AD8397 Die Rev

PCN Data Sheet Changes

AD8397 Ballast Resistors Die Revision

Figure 9. Output-to-Output Crosstalk vs. Frequency
($V_S = \pm 5\text{ V}$, $V_O = 1\text{ V p-p}$, $R_L = 25\ \Omega$)

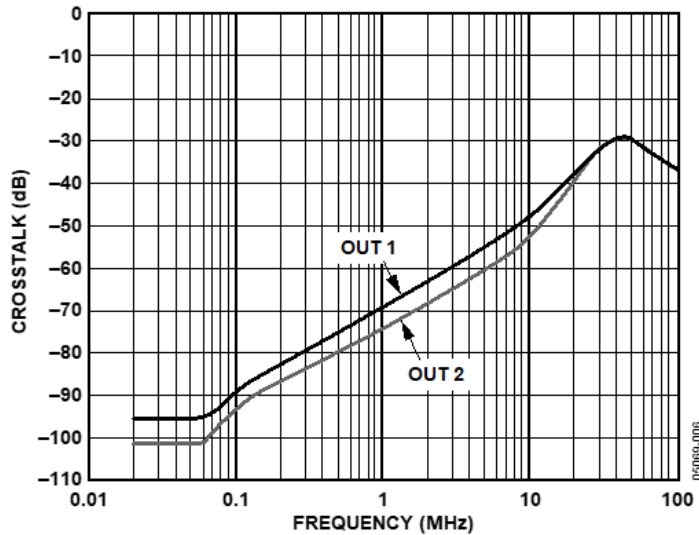
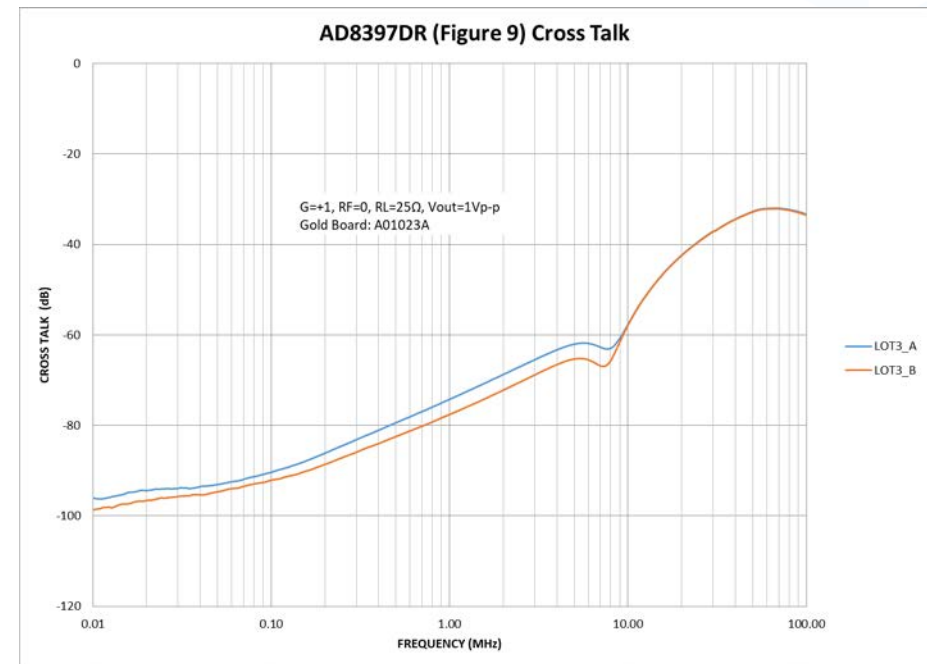
► From:

► To:

Figure 10. 0.1 dB Flatness

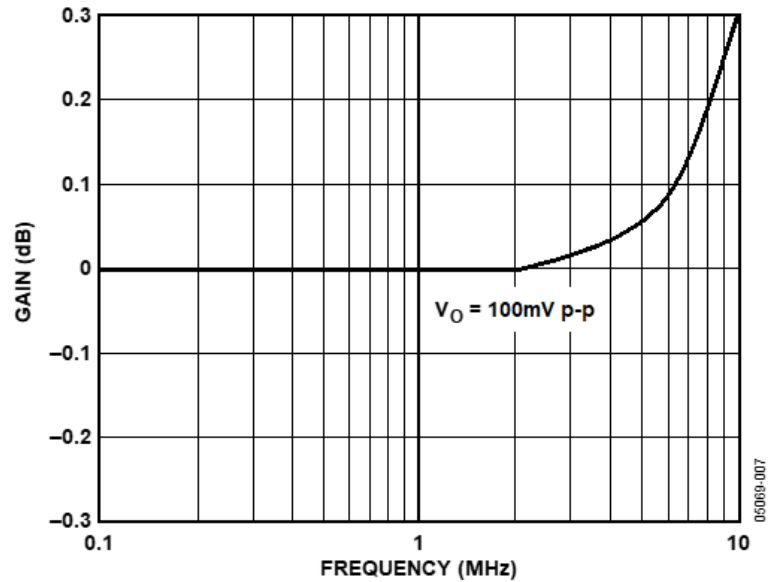
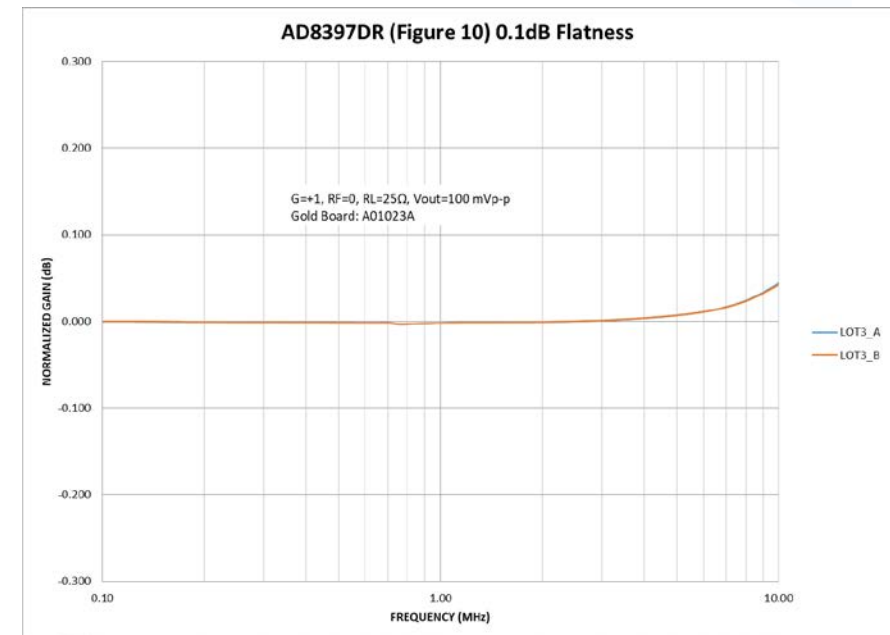
► From:

► To:

Figure 12. Small Signal Frequency Response for Various Supplies
(Gain = +1, $V_O = 0.1$ V p-p, $R_L = 25 \Omega$)

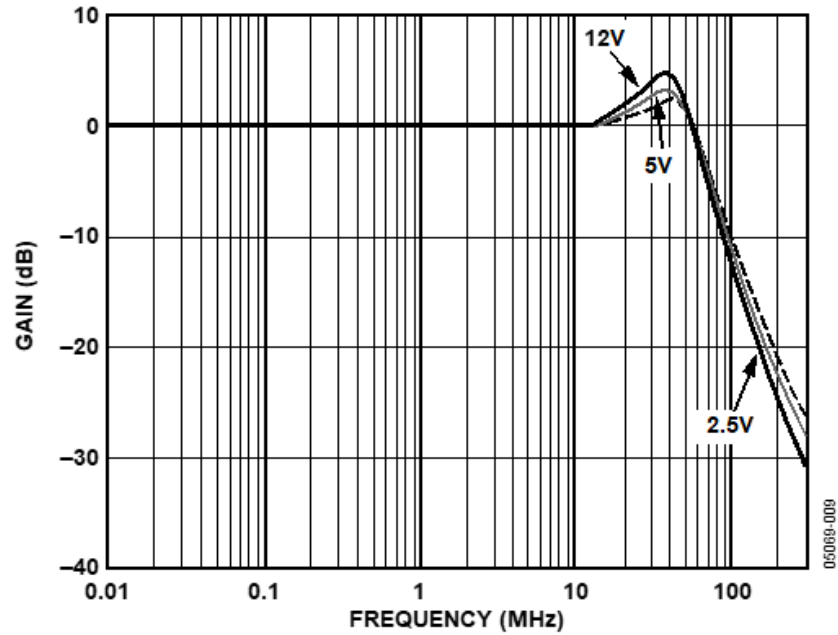
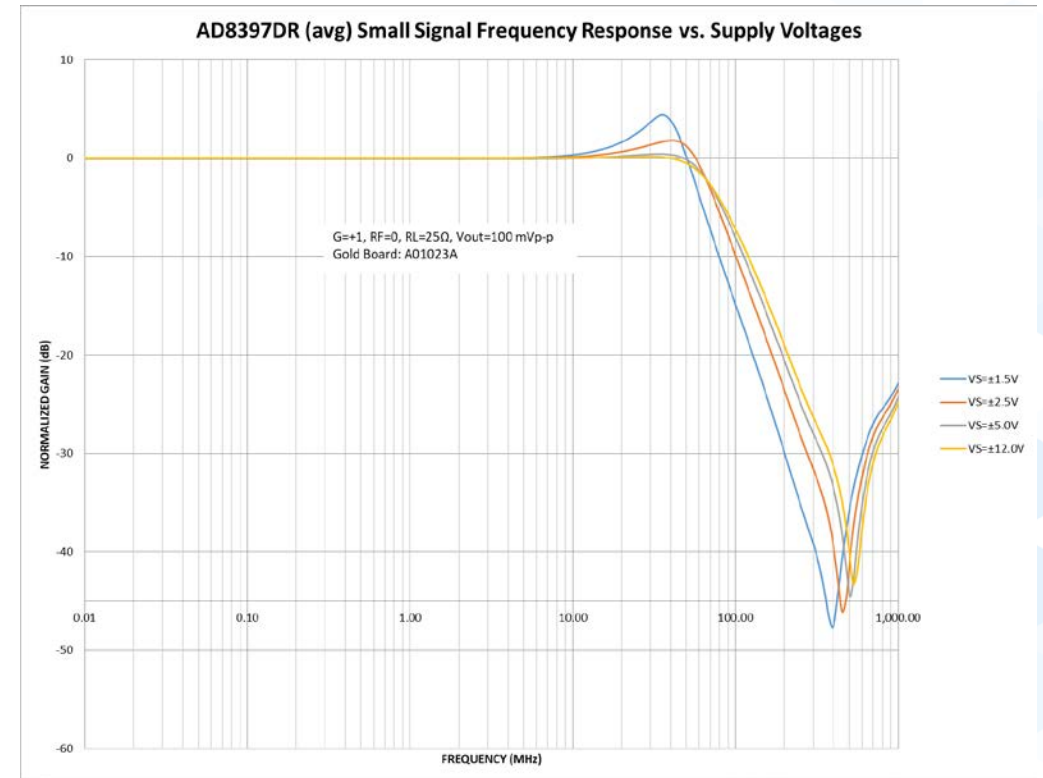
► From:

► To:

Figure 14. Large Signal Frequency Response for Various Gains
($V_S = \pm 5\text{ V}$, $V_O = 2\text{ V p-p}$, $R_L = 25\ \Omega$)

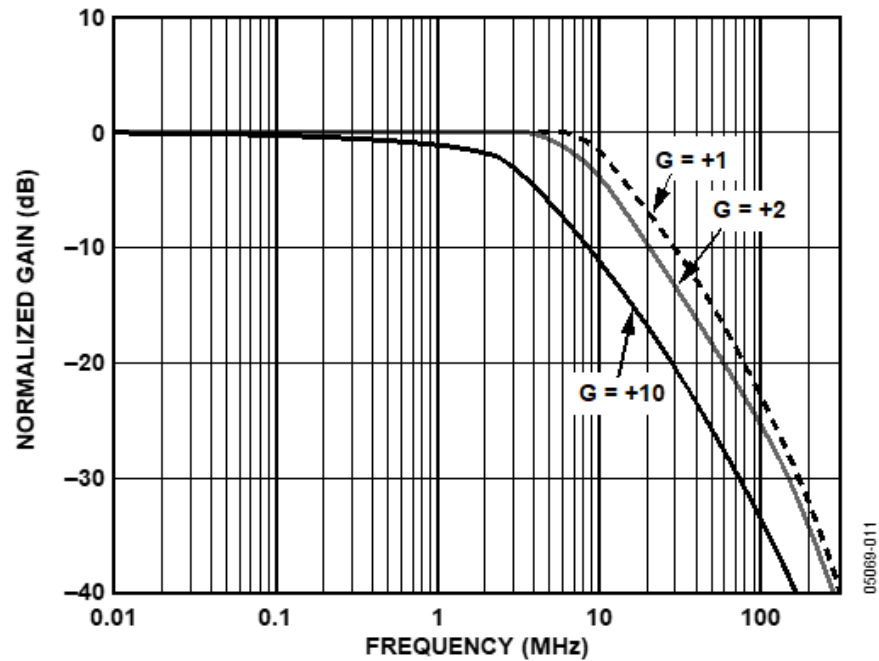
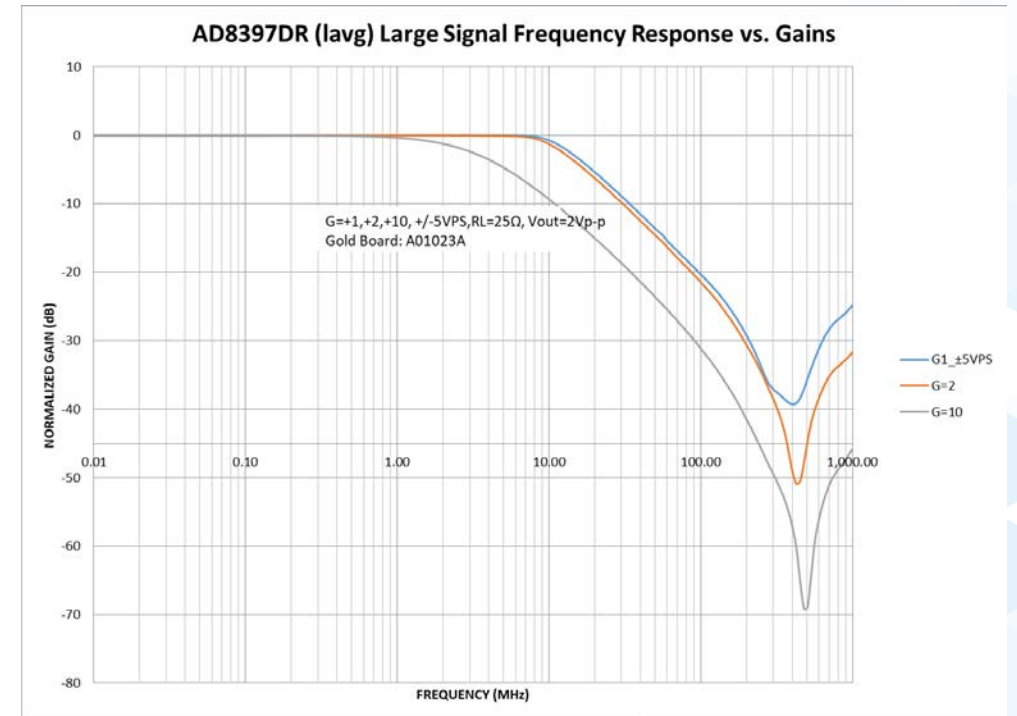
► From:

► To:

Figure 15. Large Signal Frequency Response for Various Supplies
(Gain = +1, $V_O = 2\text{ V p-p}$, $R_L = 25\ \Omega$)

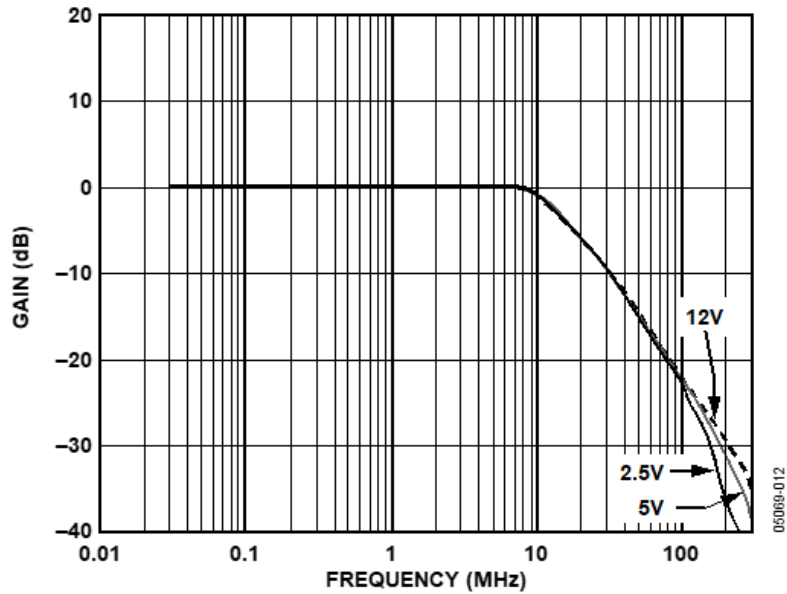
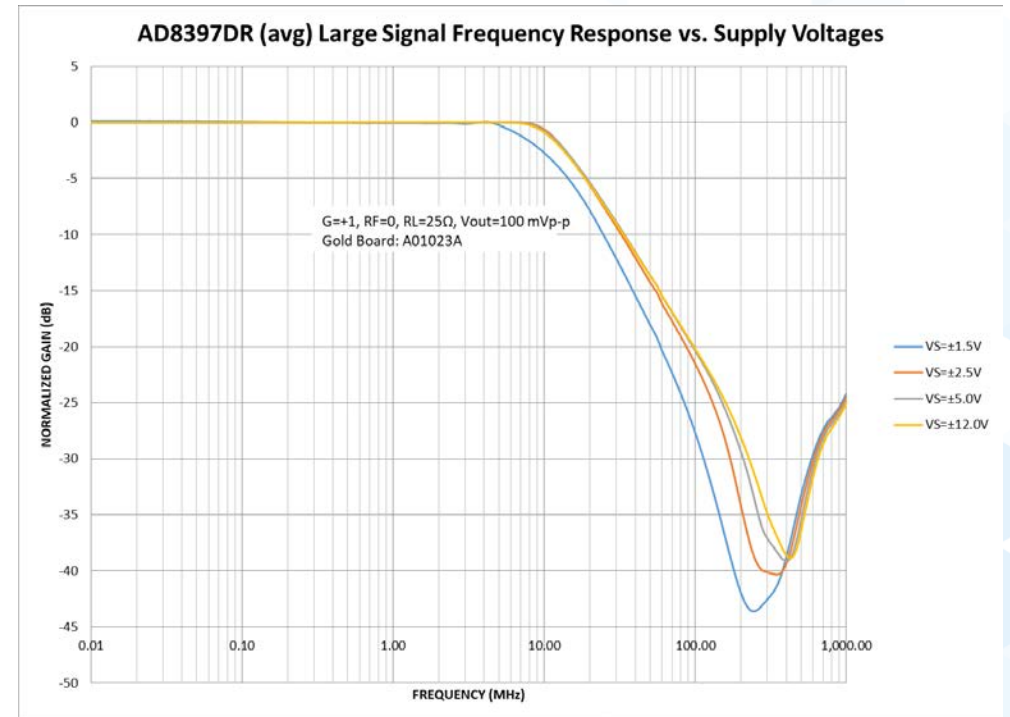
► From:

► To:
